# DESIGN STATEMENT

RETENTION ALTERATIONS TO PERMITTED SHD  
(VIA LRD PROCESS)

LOCATION  
LANDS AT PALMERS GATE, KENNELSFORT ROAD LOWER,  
PALMERSTOWN, DUBLIN 20

JULY 2025

Figure 36. ESB-Substation Location, Floor Plan and Elevations – Extracted from Existing Scheme

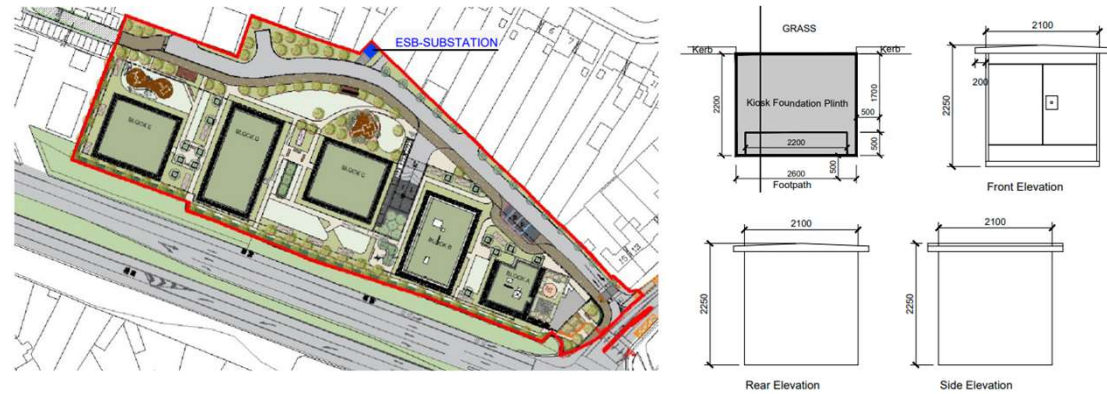
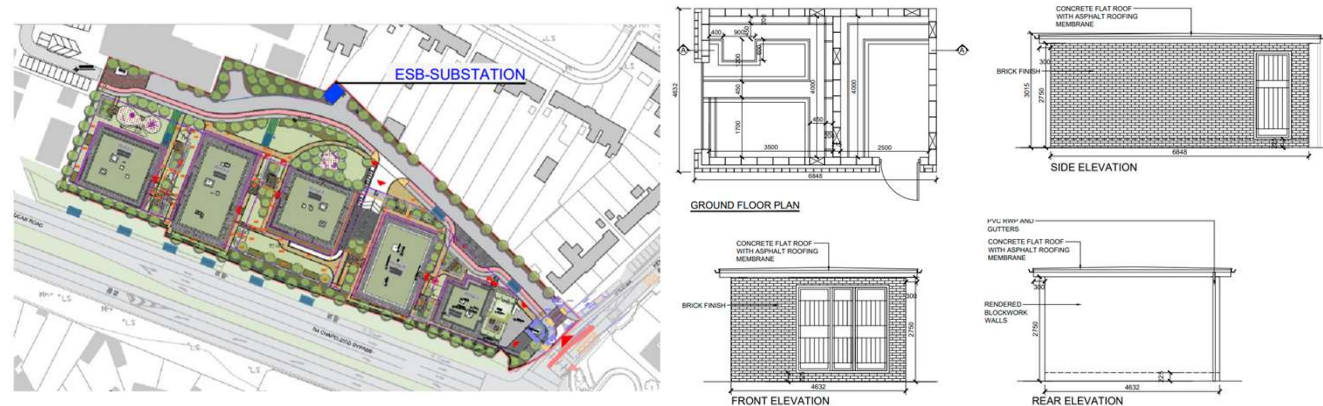
The substation in the existing scheme is larger than the one approved in the original SHD permission. Its footprint increased from 2,100mm x 2,700mm to 6,848mm x 4,632mm, and the overall height increased from 2,000mm to 3,015mm. These changes reflect in both size and height to meet operational requirements.

Figure 38. Basement Floor Plan – Extracted from Existing Scheme

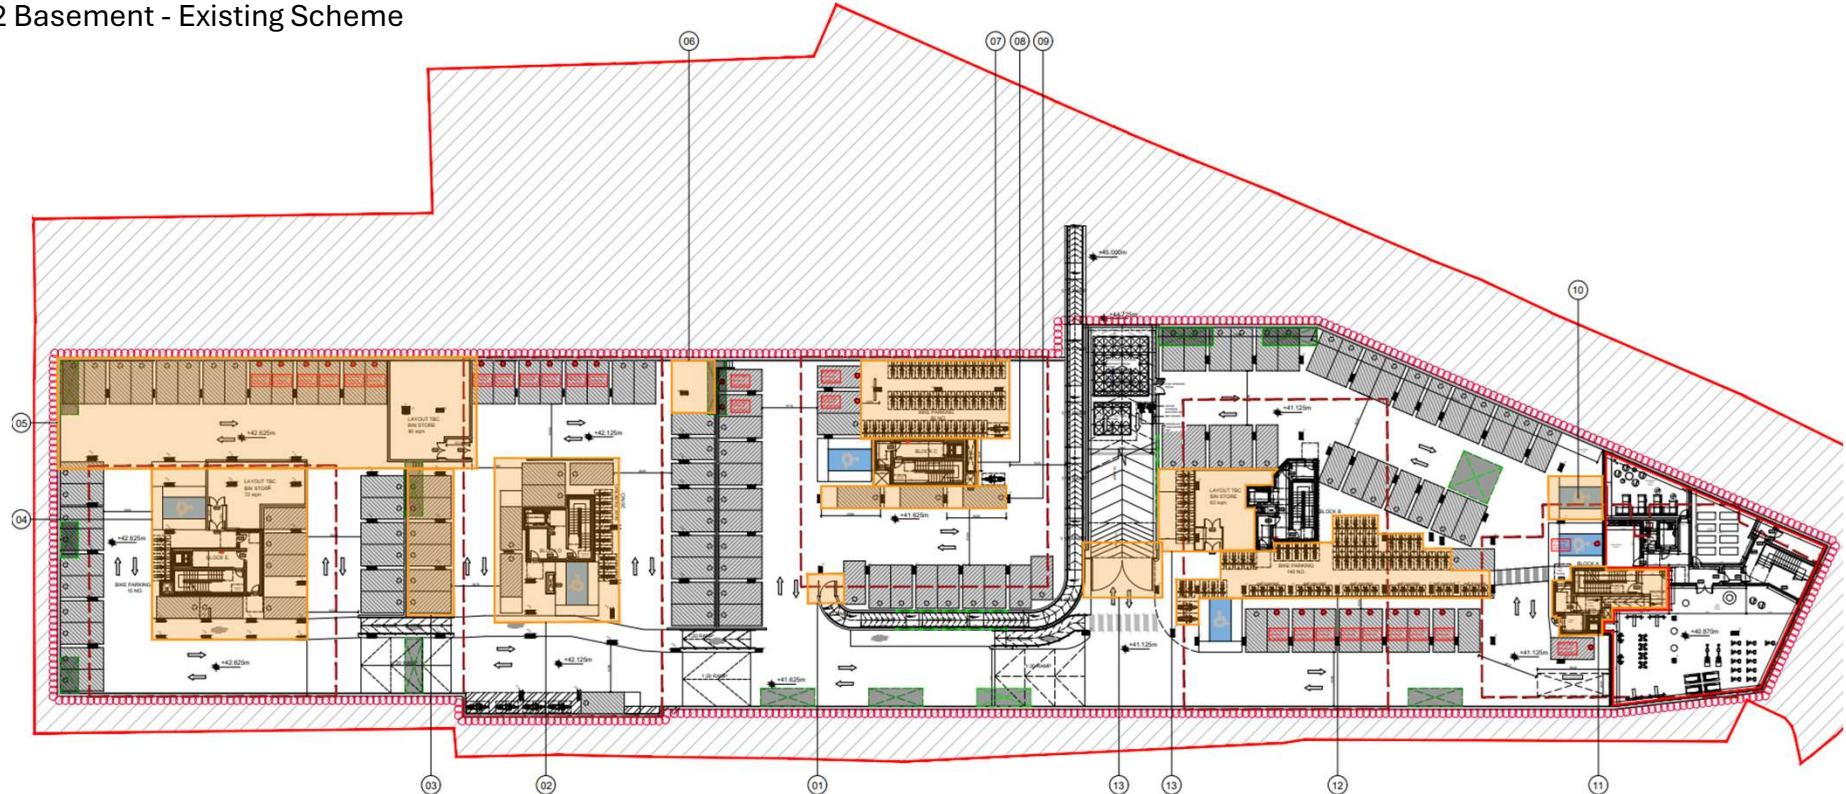
- 01 - Added door at pedestrian entrance;
- 02 – Stair core adjusted to include extra protected lobby; bike and car parking layouts revised;
- 03 - Bin store removed, replaced with car spaces;
- 04 – Stair core reconfigured with additional lobby and new bin store; parking layouts updated;
- 05 - Basement enlarged, allowing more car parking and bin storage;
- 06 - Bike parking layout revised;
- 07 - Bike parking layout revised;
- 08 - Additional protected lobby added to stair core;
- 09 – Car parking layout revised;

- 10 - Two standard car spaces replaced by one accessible space;
- 11 – Stair core updated with protected lobby and shaft;
- 12 - Bike parking layout modified;
- 13 - Smaller bin store with added bike parking;
- 14 - Gate added at basement entrance;

**Note:** The existing basement provides 18 additional car parking spaces. The number of bicycle parking spaces remains as granted, with a total of 266 spaces provided within the basement.

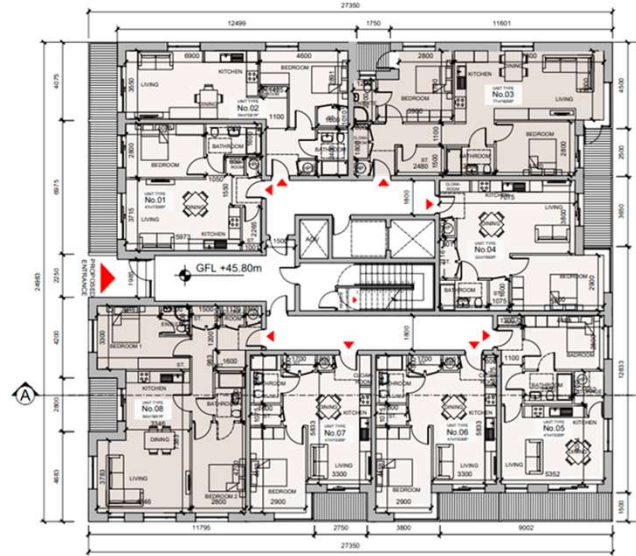
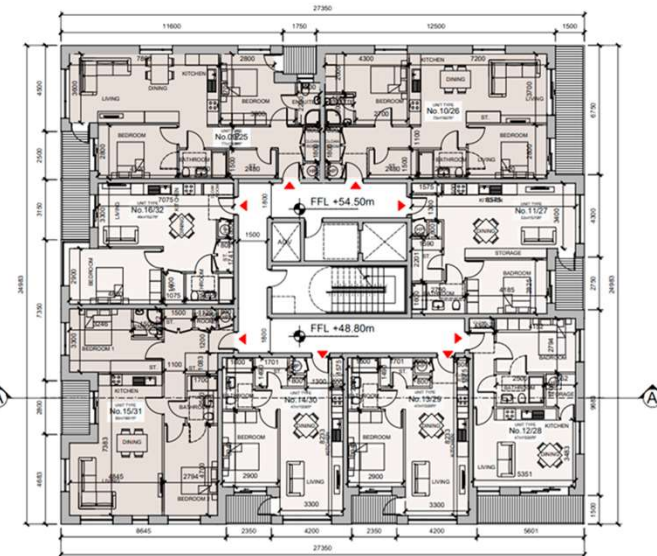
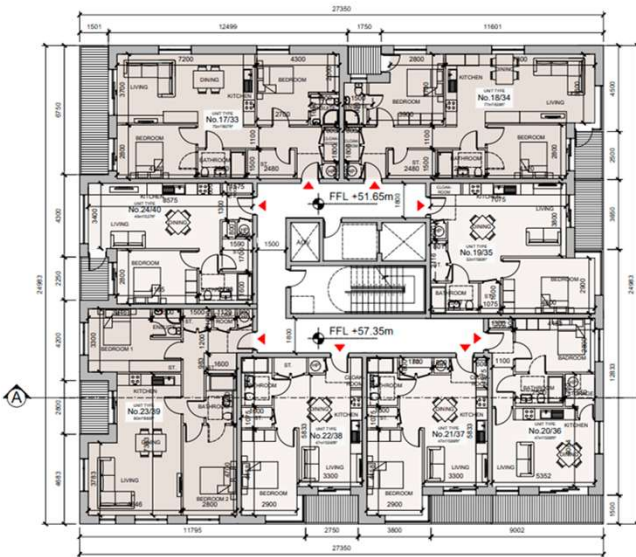
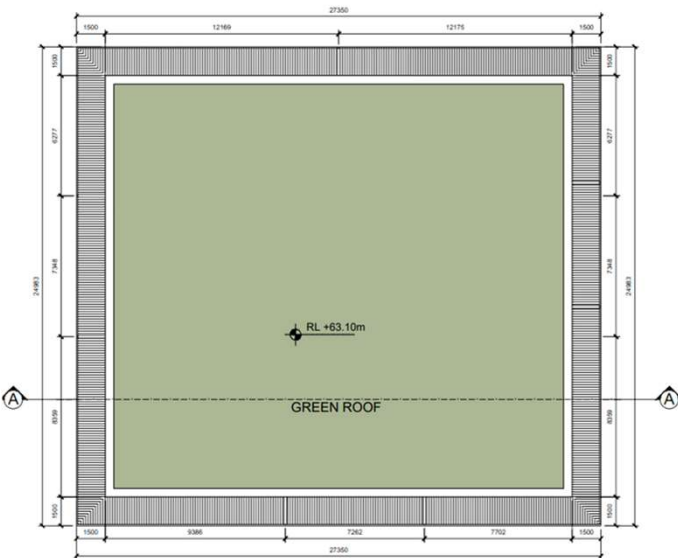
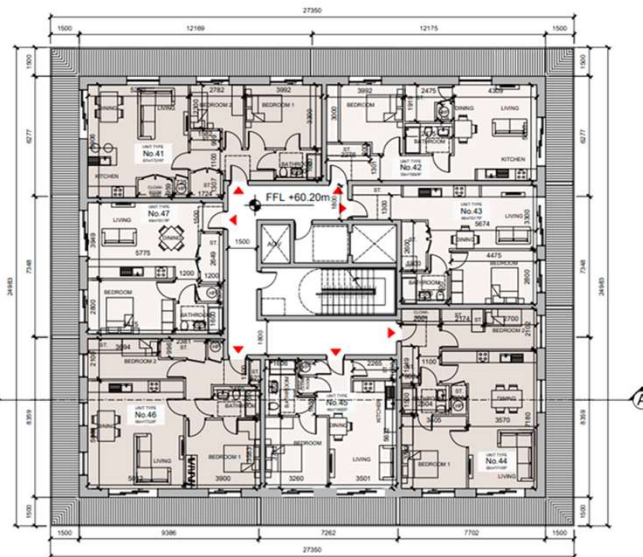
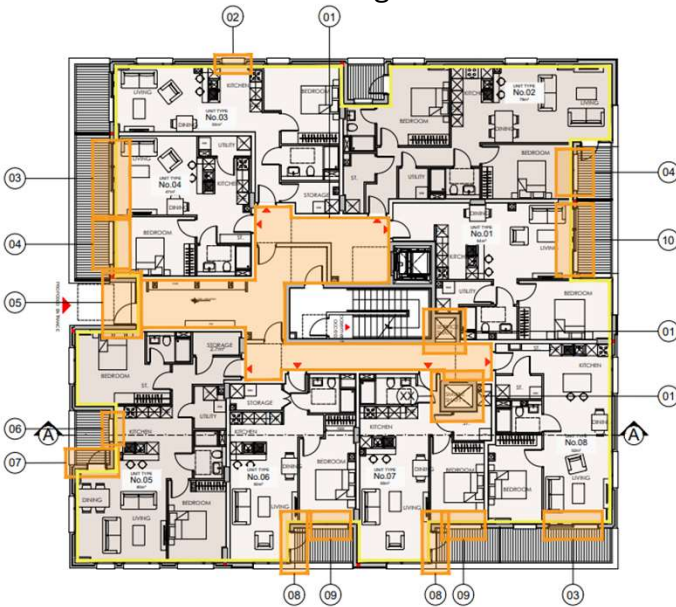
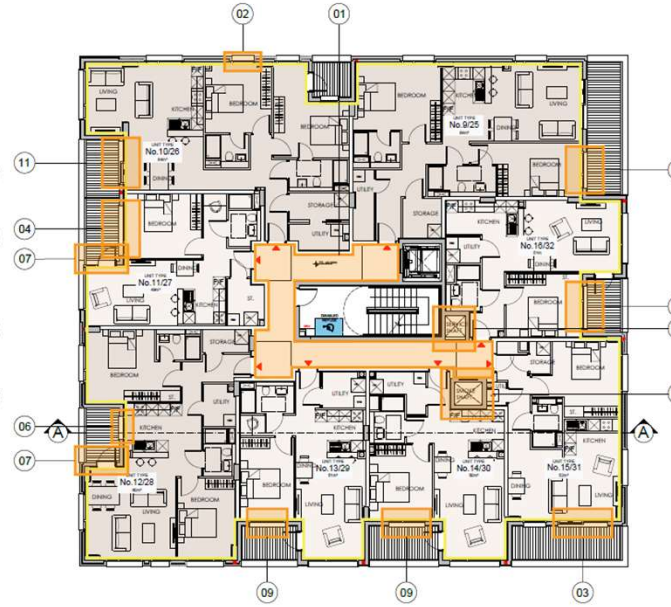
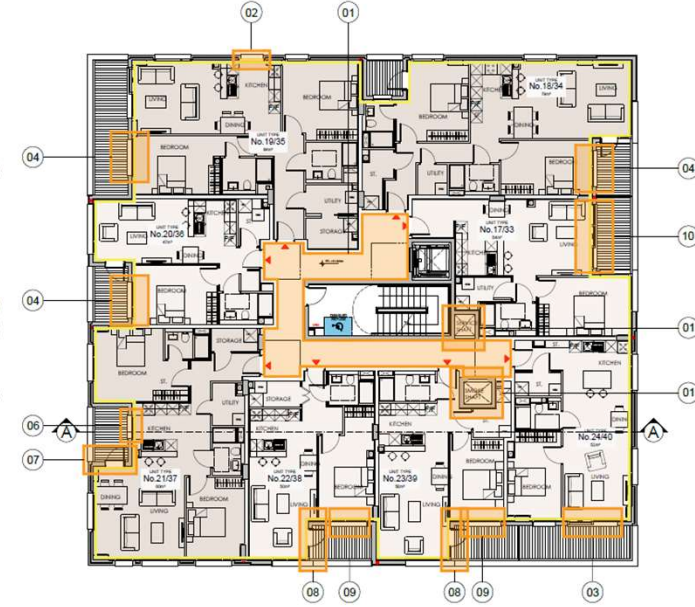
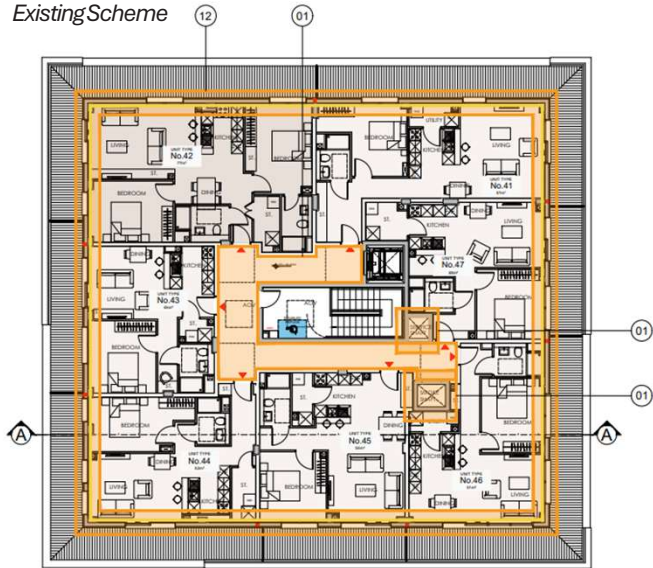
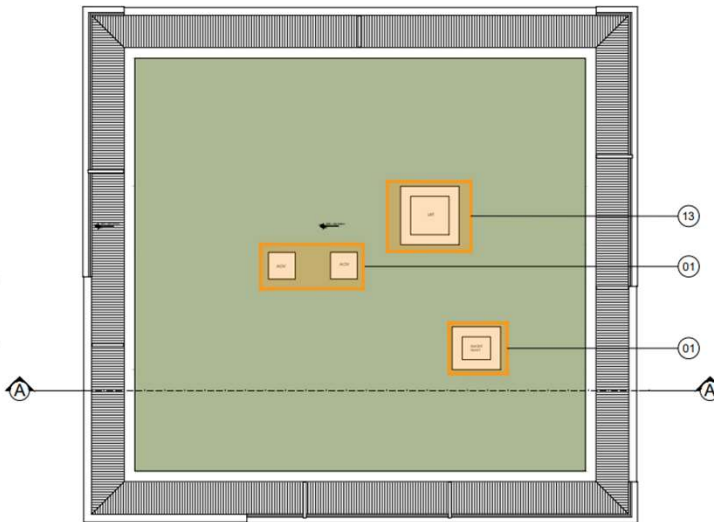
- 01 – As Granted: Simple access to the units;  
Existing: The corridor layout has been reconfigured due to the inclusion of AOV;
- 02 – As Granted: Provision one window for the living area;  
Existing: A new window was built due to a change in the kitchen layout;

- 03 – As Granted: Provision of a triple sliding door;  
Existing: A double opening window was built;
- 04 – As Granted: Provision of a double sliding door;  
Existing: A double opening window was built;

- 05 – As Granted: Opening the access door from the right;  
Existing: Main access door opening changed to the left;
- 06 – As Granted: Provision of a double sliding door;  
Existing: A single opening window was built;

- 07 – As Granted: No access to open space;  
Existing: A single door was built to access the new balcony;
- 08 – As Granted: Provision of a window;  
Existing: A door was built to access the balcony;

- 09 – As Granted: Provision of a double sliding door;  
Existing: A double opening window was built;
- 10 – As Granted: Provision of a double sliding door;  
Existing: A triple sliding door was built increasing the dimensions of the opening;

- 11 – As Granted: Provision of a double sliding door;  
Existing: Larger double sliding door was built;
- 12 – As Granted: Provision of window and door openings for a Penthouse layout for 3 no. 2-BEDS unit and 4 no. 1-BED;  
Existing: Layout has been reconfigured to a Penthouse with 1 no. 2-BEDS unit and 6 no. 1-BED units so all the window and door openings were built in different positions or dimensions;

- 13 – As Granted: The previously approved lift didn't include an Engine room;  
Existing: The lift Engine room was built according to the Manufactures specifications, changing the design seen in the roof plan and elevation.

**Note:** All internal layouts of the units for all floors have been changed compared to the previously approved layout (As Granted Scheme). However only the Fifth floor (Penthouse) has seen a change in the type of the units, where previously approved was 3 no. 2-BEDS and 4 no. 1-BED units, and now has 1 no. 2-BEDS and 6 no. 1-BED units.

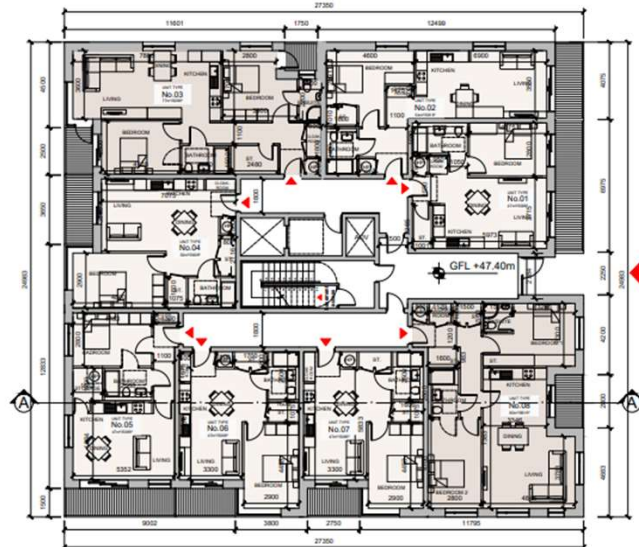
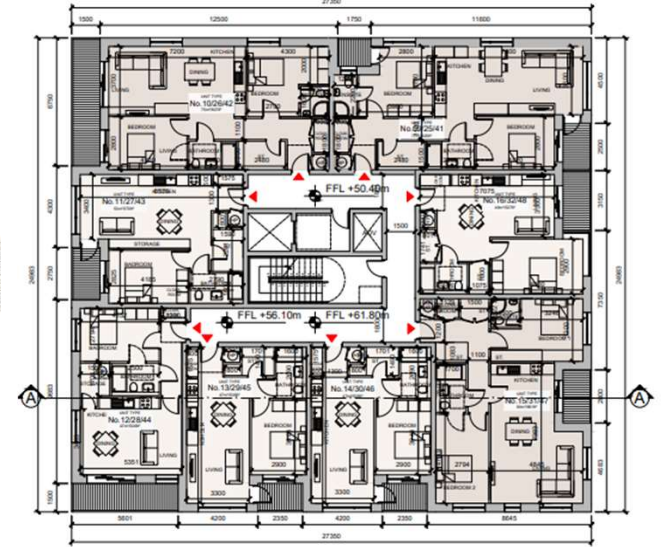
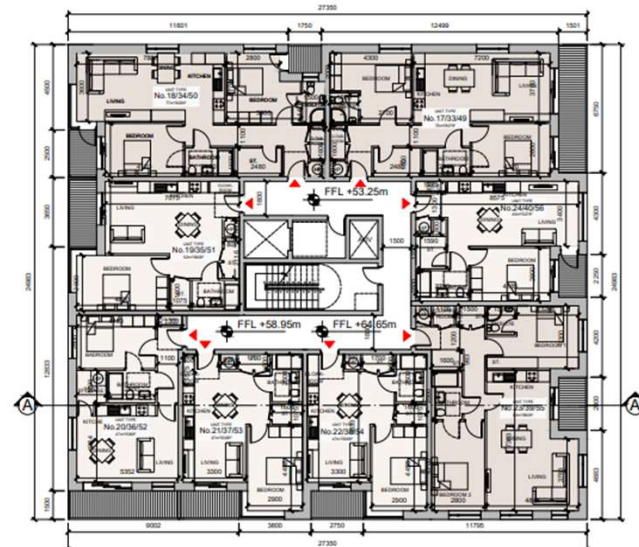
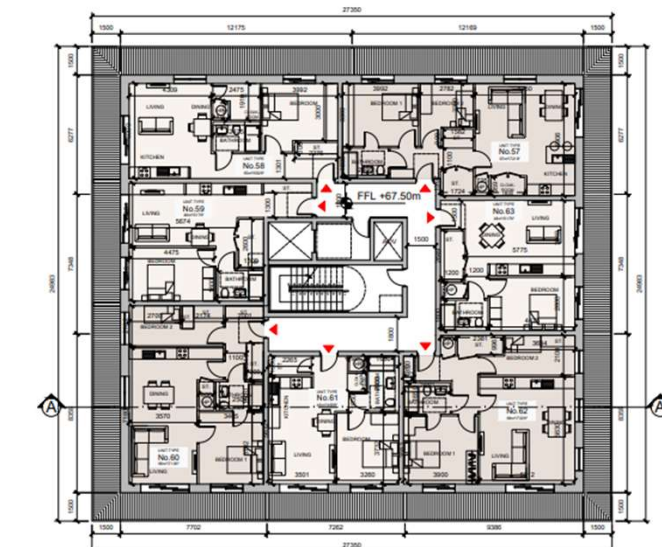
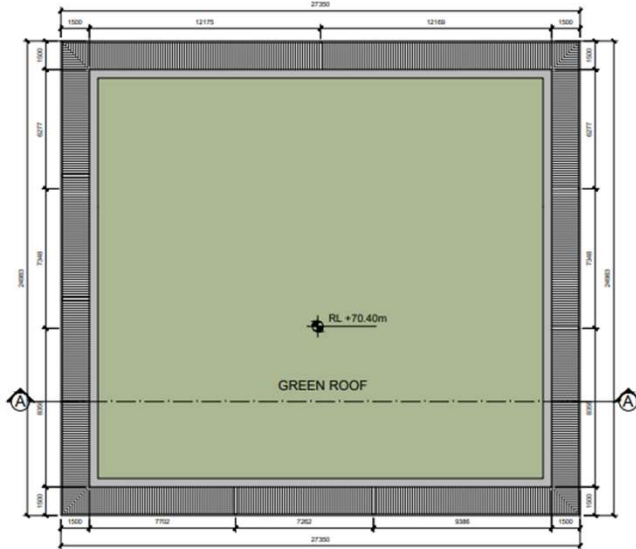
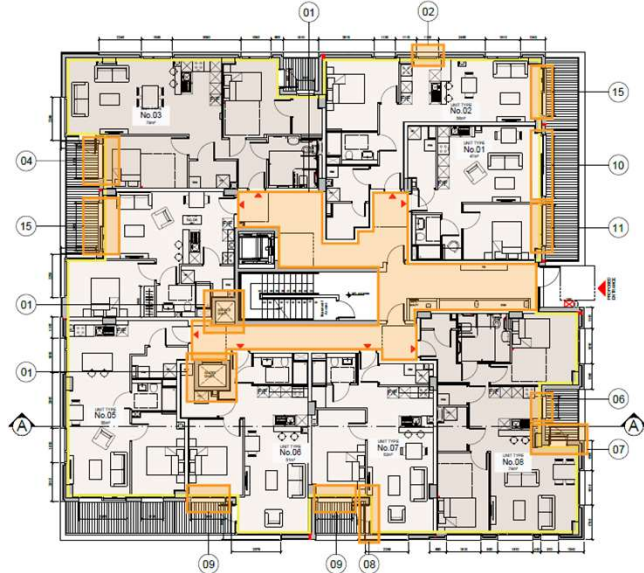
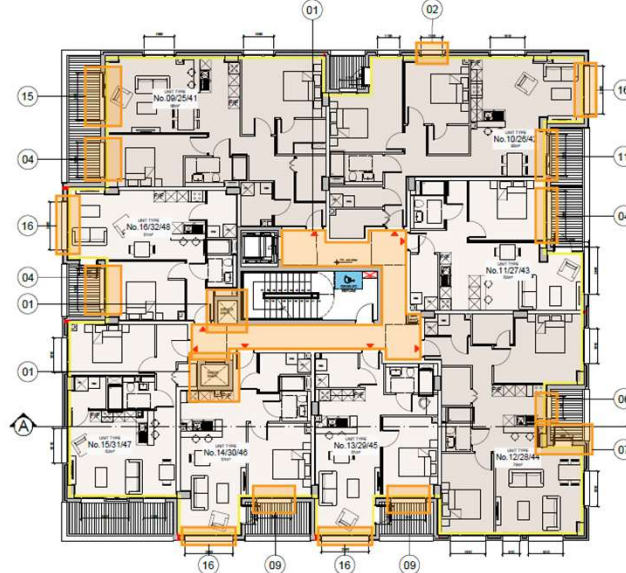
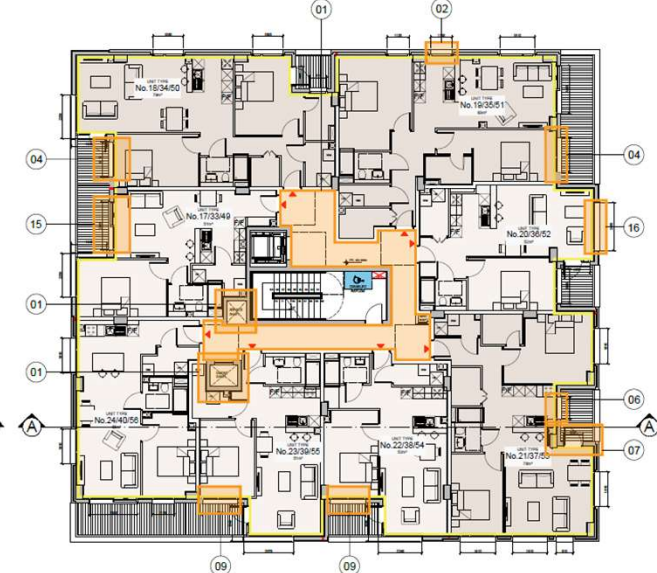
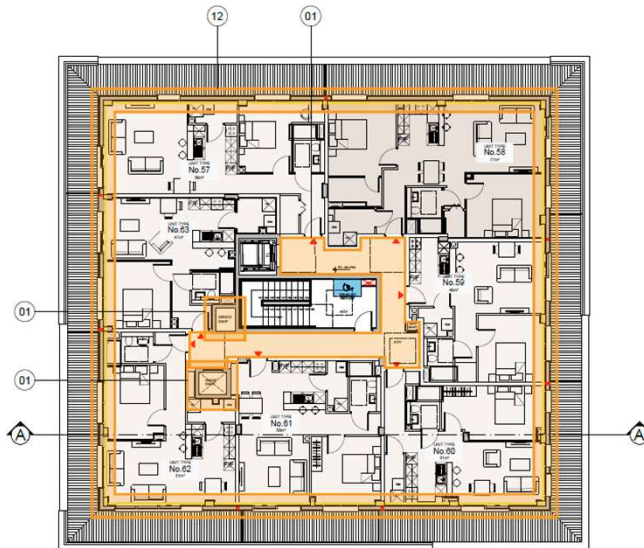
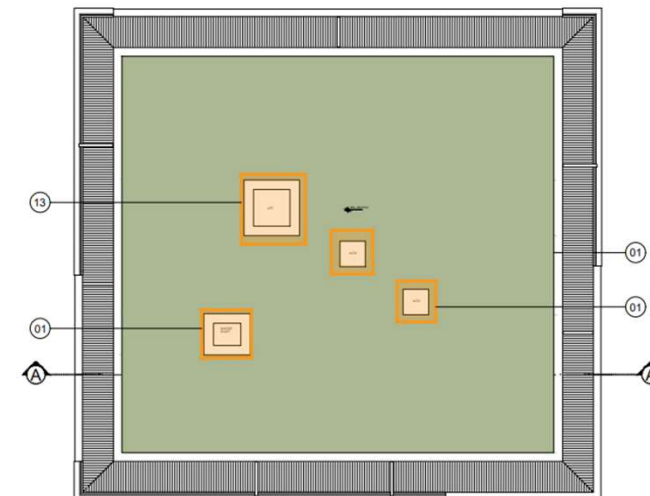
- 01 – As Granted: Simple access to the units;  
Existing: The corridor layout has been reconfigured due to the inclusion of AOV;
- 02 – As Granted: Provision one window for the living area;  
Existing: A new window was built due to a change in the kitchen layout;

- 03 – As Granted: Provision of a triple sliding door;  
Existing: A double opening window was built;
- 04 – As Granted: Provision of a double sliding door;  
Existing: A double opening window was built;

- 05 – As Granted: Opening the access door from the right;  
Existing: Main access door opening changed to the left;
- 06 – As Granted: Provision of a double sliding door;  
Existing: A single opening window was built;

- 07 – As Granted: No access to open space;  
Existing: A single door was built to access the new balcony;
- 08 – As Granted: Provision of a window;  
Existing: A door was built to access the balcony;

- 09 – As Granted: Provision of a double sliding door;  
Existing: A double opening window was built;
- 10 – As Granted: Provision of a double sliding door;  
Existing: A triple sliding door was built increasing the dimensions of the opening;

- 11 – As Granted: Provision of a double sliding door;  
Existing: Larger double sliding door was built;
- 12 – As Granted: Provision of window and door openings for a Penthouse layout for 3 no. 2-BEDS unit and 4 no. 1-BED;  
Existing: Layout has been reconfigured to a Penthouse with 1 no. 2-BEDS unit and 6 no. 1-BED units so all the window and door openings were built in different positions or dimensions;

- 13 – As Granted: The previously approved lift didn't include an Engine room;  
Existing: The lift Engine room was built according to the Manufactures specifications, changing the design seen in the roof plan and elevation;

- 14 – As Granted: Provision of a double sliding door;  
Existing: A triple opening window was built;
- 15 – As Granted: Provision of a double sliding door;  
Existing: A triple sliding door was built;

- 16 – As Granted: Provision of a double window;  
Existing: A triple opening window was built.
